AMENDMENT - INVITATION TO TENDER

Title-Sujet: Construction – Wabasca-Desmarais Detachment	
Solicitation No. - No. de l'invitation 201804138	Date 31 janvier, 2018
Client Reference No. - No. De Référence du Client 201804138	Amend No.- No. du modif. 005
GETS Reference No. - No. de Référence de SEAG 201804138	
Solicitation Closes – L'invitation prend fin at - à 14 :00 ET on - le Feb. 6th, 2018	
F.O.B. - F.A.B. Destination	
Address Enquiries to: - Adresser toutes questions à: jordan.mckenna@rcmp-grc.gc.ca	
Telephone No. - No de telephone 613.843.5518	Fax No. - Nº de FAX:
Destination of Goods, Services, and Construction: Destinations des biens, services et construction:	
Delivery Required - Livraison exigée:	Delivery Offered - Livraison proposée
Name and title of person authorized to sign on behalf of Vendor/Firm Nom et titre de la personne autorisée à signer au nom du fournisseur/de l'entrepreneur

ADDENDUM No. 04

GOVERNMENT OF CANADA WABASCA-DESMARAIS GOVERNMENT BUILDING

2 OUT BUILDING ELECTRICAL PLAN
E4.0 SCALE: 1:100

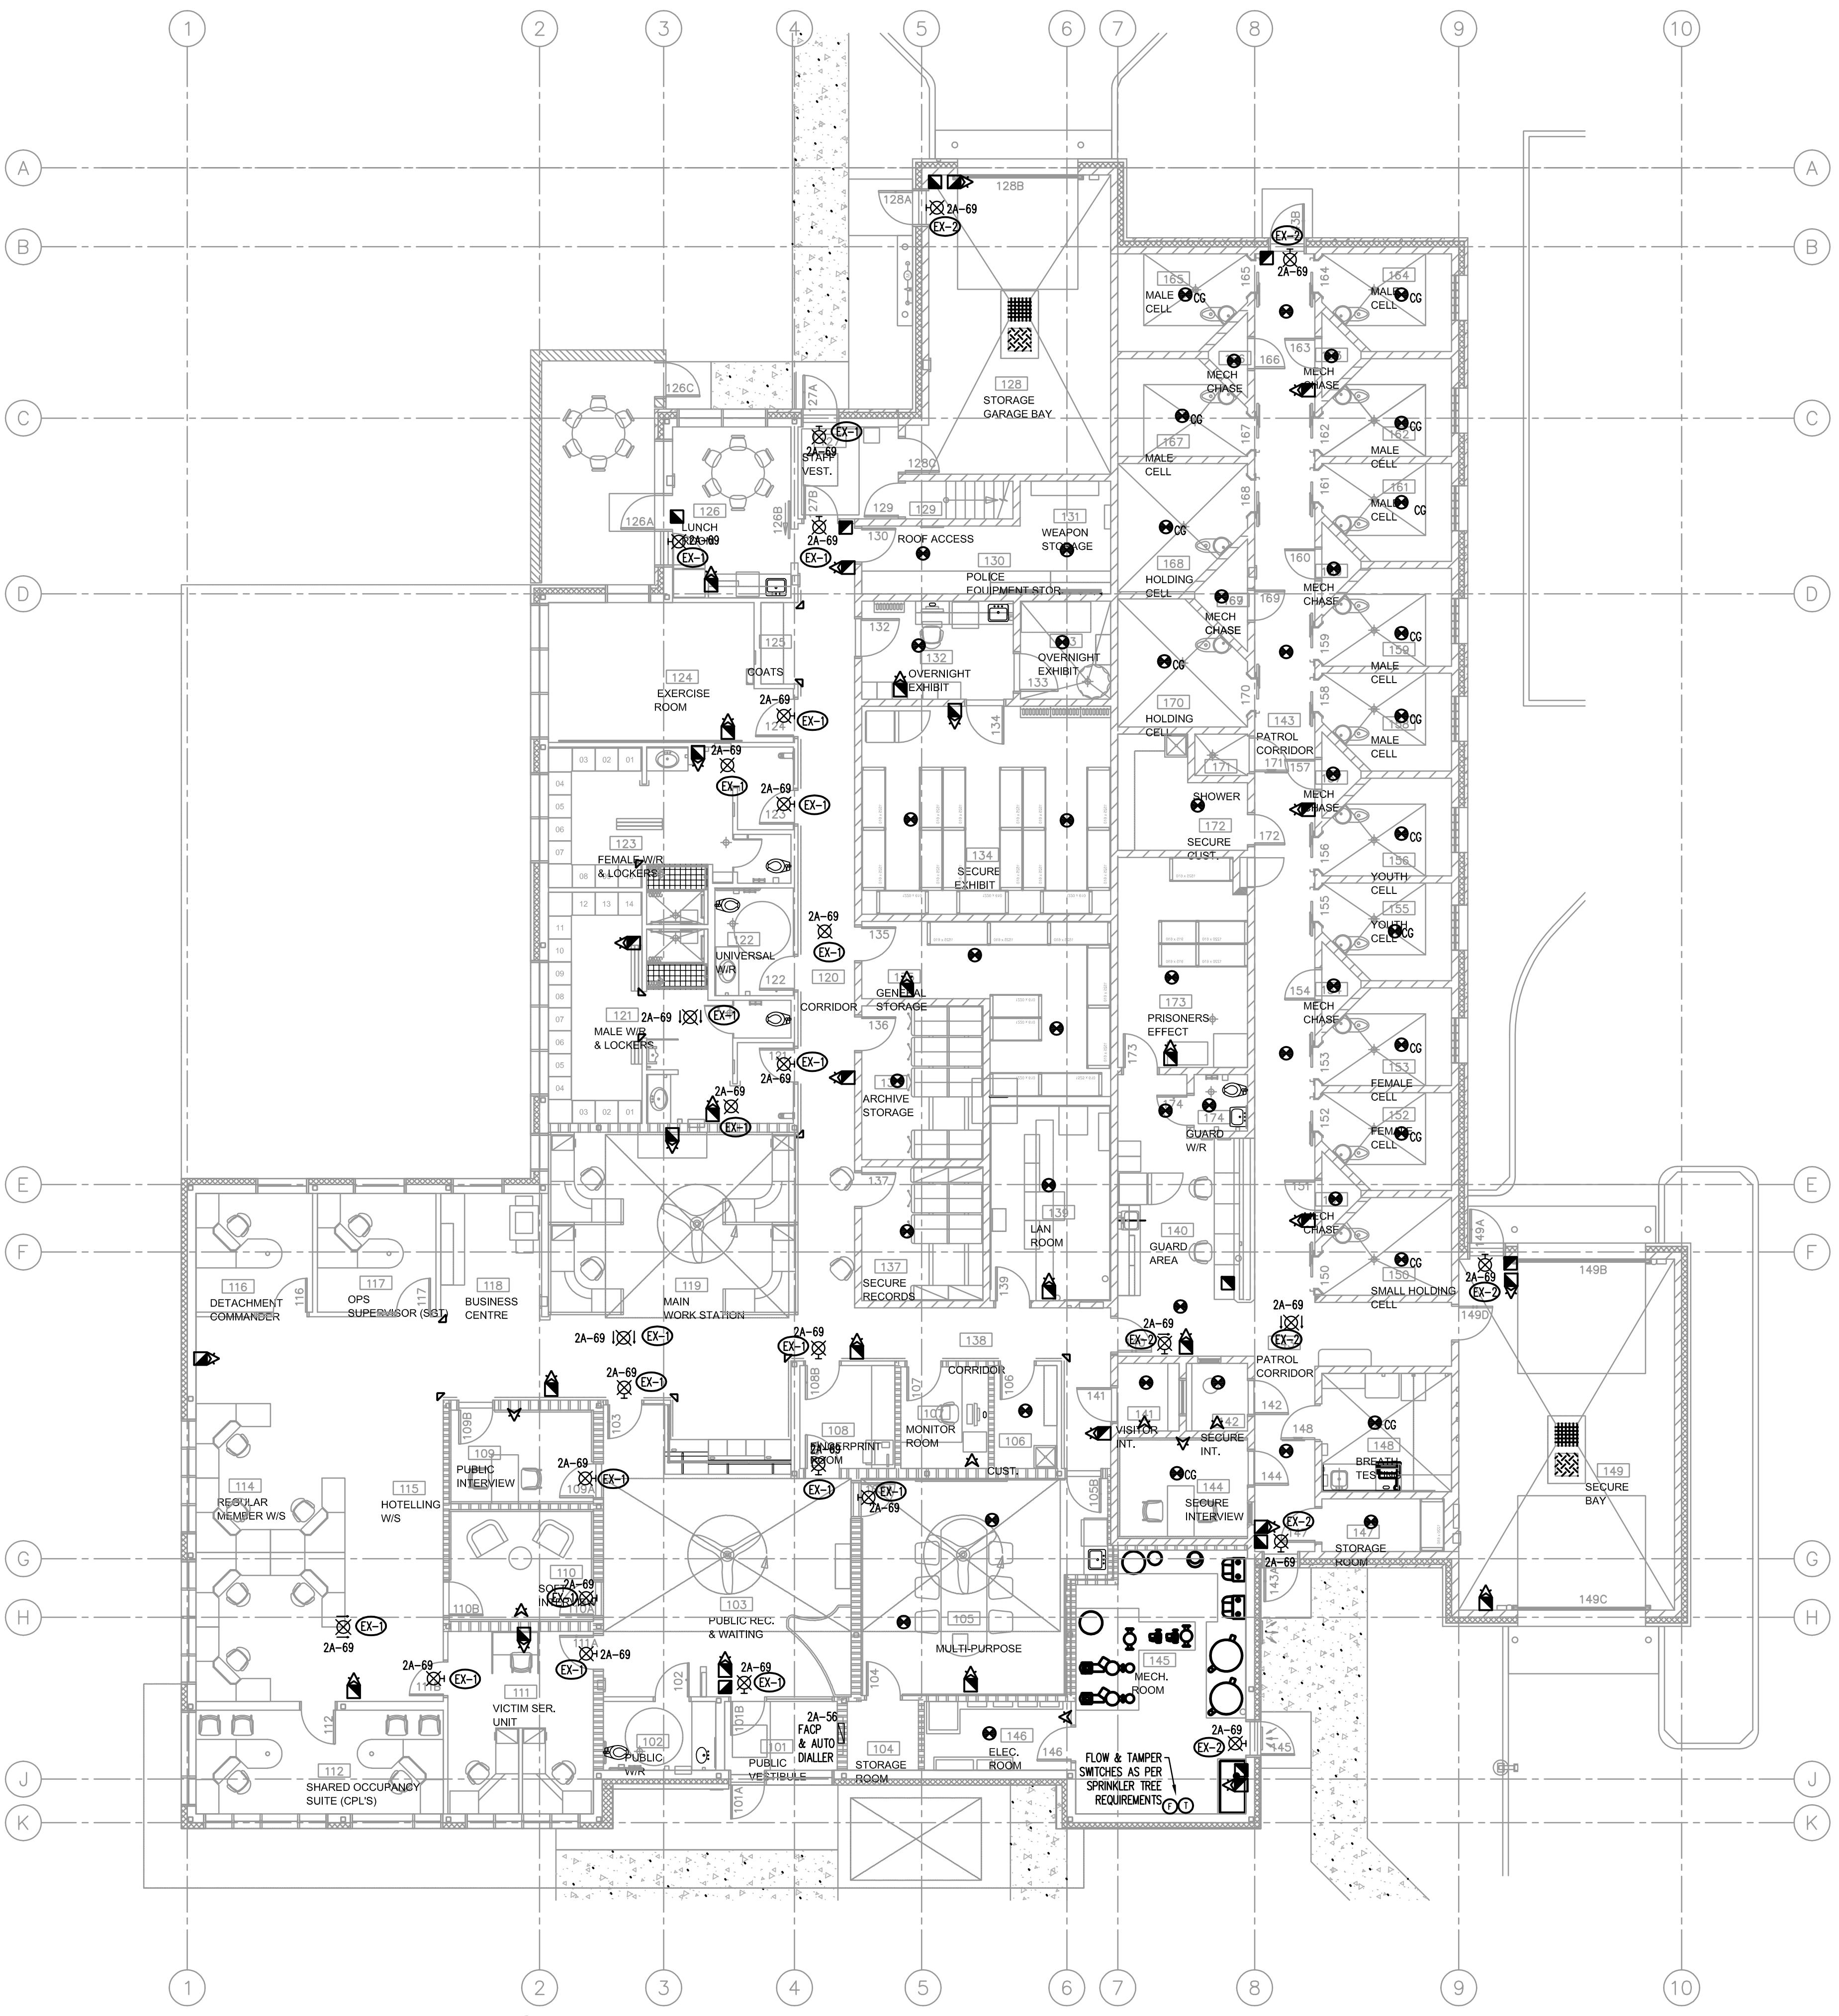
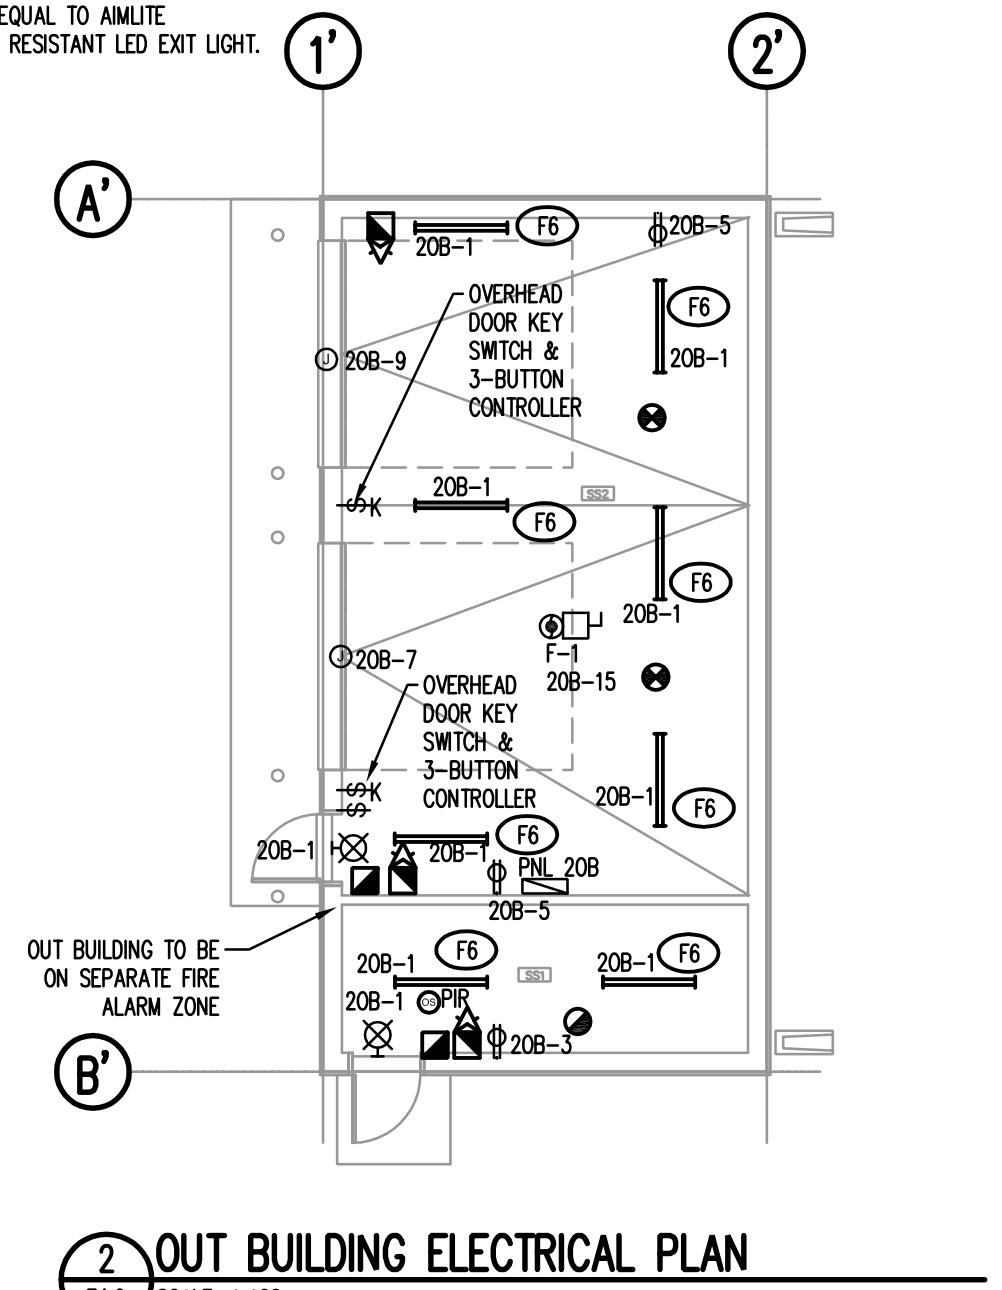
2. Drawing E4.0

REVISE: Drawing has been re-issued with this addendum to address alignment issues.
